## MEMORANDUM

**To:** The Design Advisory Board  
**From:** Mary O'Neil, AICP, Senior Planner  
**RE:** ZP 15-0704CA/CU; 61 Summit Street  
**Date:** January 13, 2015

**File:** 15-0704CA/CU  
**Location:** 61 Summit Street / 411 Main Street  
**Zone:** I **Ward:** 1  
**Date application accepted:** December 22, 2014  
**Applicant/ Owner:** University of Vermont  
**Request:** Exterior rehabilitation of Alumni House at 61 Summit Street; new construction of a pavilion and connector building; landscaping, pedestrian and vehicular circulation; drainage improvements. Plan includes site alterations to 411 Main Street which will require a separate zoning permit application and review.  
**Staff site visit:** January 5, 2015.

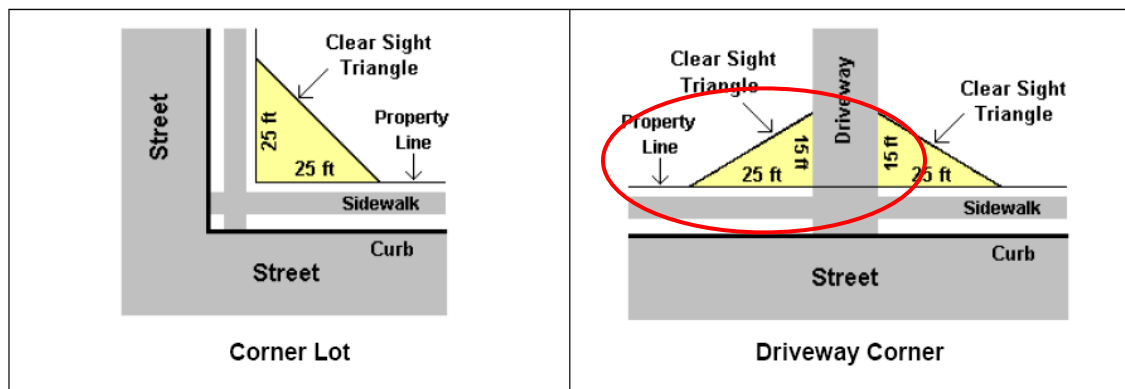
A 4' fence is illustrated on the southwest of the parcel; presumably to ban pedestrian foot traffic in the existing pattern of use. See Plan A6.5 for detail drawing.

From Plan A1.1, it appears that the fence does not meet the required 25' separation from the westerly driveway entrance, as illustrated below. If the fence location is important to the plan, then the fence must be reduced in height to 3' if within that "clear site triangle."

4. Fence placement must meet the Clear Site Triangle as noted in 6.2.2. (m.), above.
5. A separate zoning permit application must be filed for the 411 Main Street parcel.
